From: Hardeep Hunjan [REDACTED]
Sent: 10 September 2021 07:53
To: Brenda Louisy-Johnson <Brenda.Louisy-Johnson@arun.gov.uk>; Claire Potts <Claire.Potts@arun.gov.uk>
[REDACTED]
Subject: FW: Sefter Road- LTN 1/20 Audit

Subject: Sefter Road- LTN 1/20 Audit

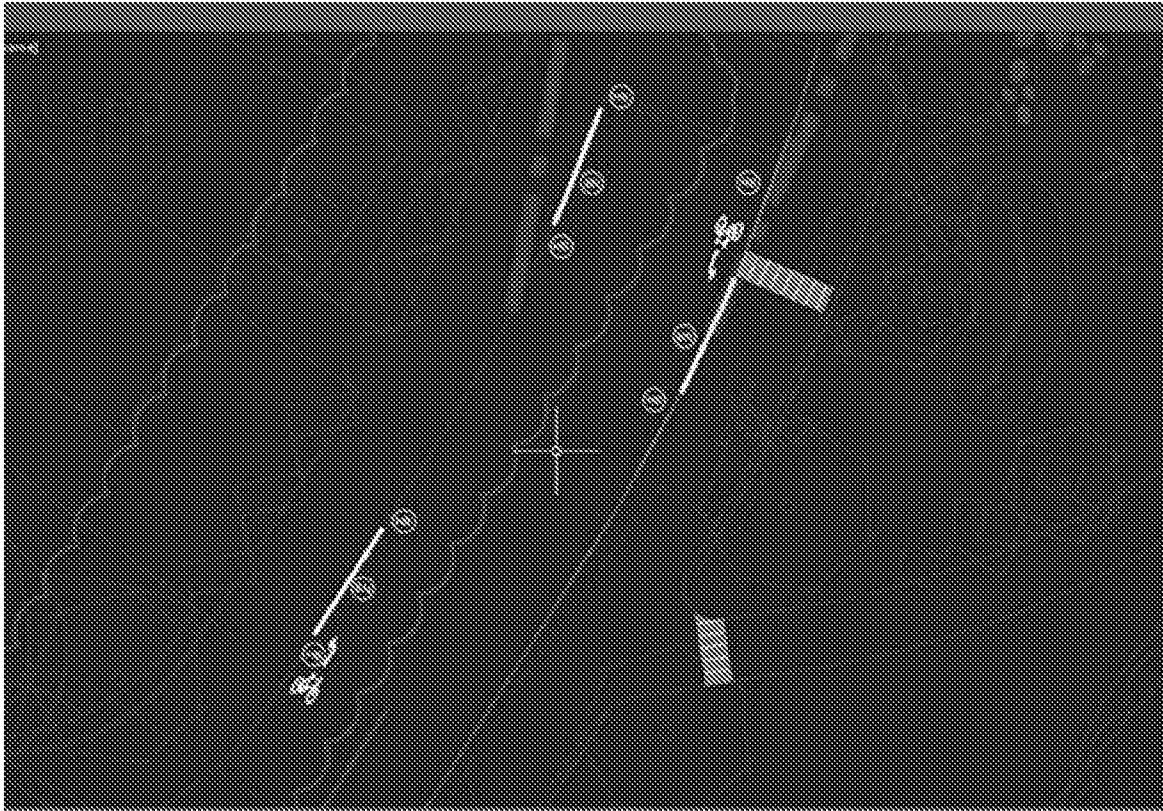
In terms of the interface of the how the cyclist get on and off the shared use cycleway I have annotated this on our visibility drawing as well as highlighted some of the key traffic calming measures along the spine road. Detailed designs of these will be included as part of the S38. For ease of reference I have included a zoomed in screen shot of the cyclists on/off provisions for the spine road
